David *EX. 6*

Caius - please look closely at the Eddy Current Examination Technique section, Section 1RS2, and section 1RS4 Items 1 and 2. I still need the graphs with the revised lines. After we talked I included your graph for R2C67 - so could you please include that in the list to redo the lines on - thanks. Also what was your depth estimate for R2C5 ?- could not find that.

SUBJECT: NRC SPECIAL INSPECTION 50-247/2000010- STEAM GENERATOR TUBE
FAILURE

Report No. 05000247/2000-010

Figure 12 - 1997 scan

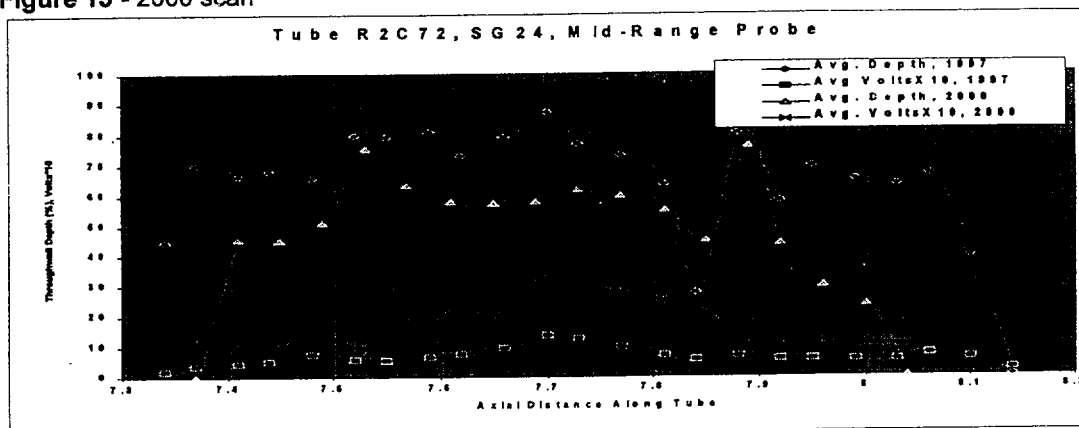
3. R2C72 in SG 24 - Figure 12, shows the c-scan plot of the 1997 data, there is considerable noise present. The crack is sitting in a ridge of noise, and barely extends above a ridge of deposits. For comparison the c-scan plot for the 2000 data is included as Figure 13. Figure 14 shows the profile. The crack barely extends above a 1-volt amplitude for a short length, and this is the only part of the crack that we can profile reliably. The depth estimate based on 1997 data is 79.2 % TW.

Figure 15 - 1997 scan

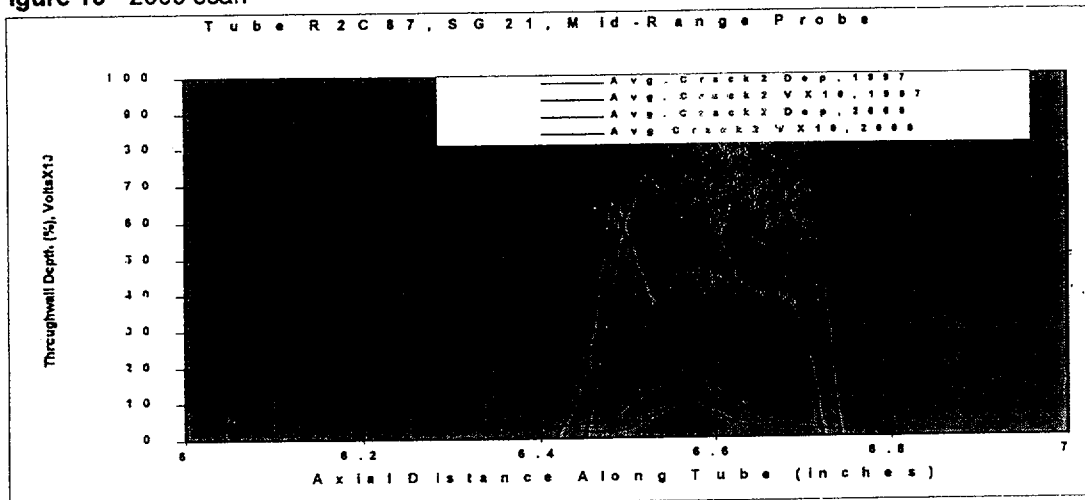
4. R2C87 in SG 21 - this tube was identified as having several cracks. Figure 15 shows the c-scan plot of the 1997 data, the most prominent crack is sitting in a relatively clean area of the tube. For comparison the c-scan plot for the 2000 data is included as Figure 16. Figure 17 shows the profile of the most prominent crack. The depth estimate based on 1997 data is 63.7% TW.

Figures 18 and 19 - Eddy Current Inspection- Tube R2C67 in SG 24**Figure 19 - Depth and voltage profile of the crack in tube 2-67 of steam generator 24 located in 1997.****Figure 18 - Crack in tube 2-67 of steam generator 24, found in 1997.**

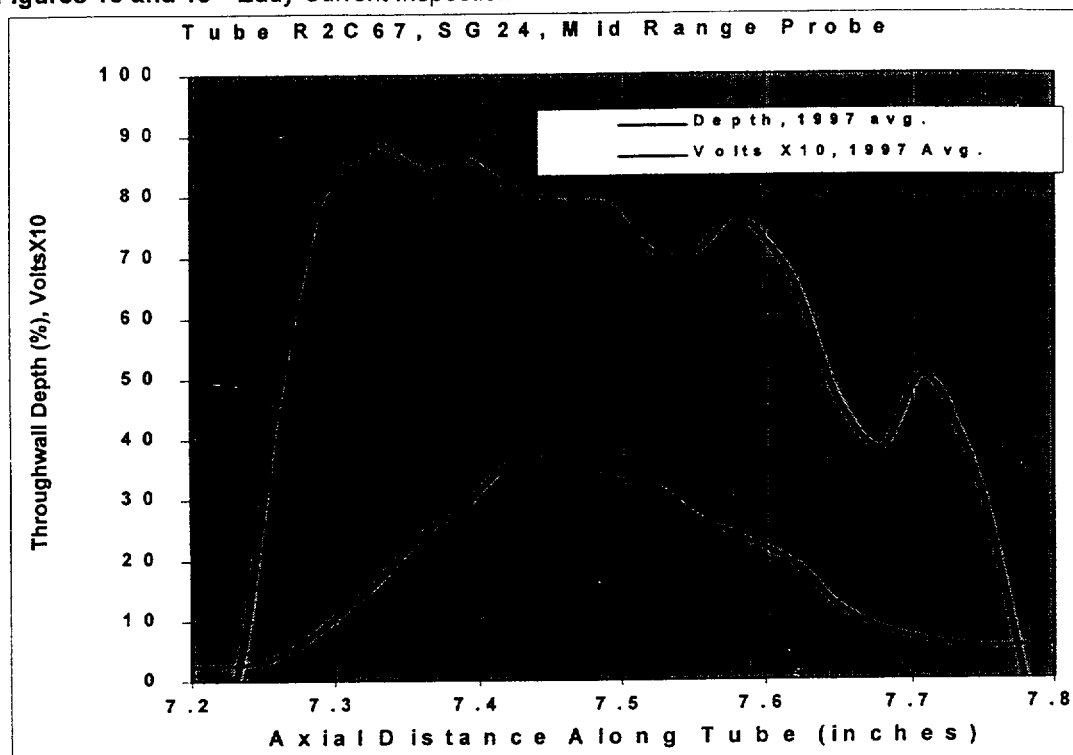
Figure 18 shows the c-scan plot of the 1997 data from R2C67, the crack sits beside a ridge, in a valley, and is in an easily detectable portion of the tube. The large amplitude of the voltage signal, in relation to the standard calibration notch would indicate that this is a "mature" crack. No year 2000 data is available since the tube was plugged in 1997. Figure 19 shows the profile. The depth estimate based on 1997 data is 87.5% TW.

The comment made by the licensee regarding the noise levels in R2C67 being bounded by the response of the samples used in the EPRI studies is believed irrelevant. The R2C67 flaw was indicated by the c-scan to be not associated with noise ridges.
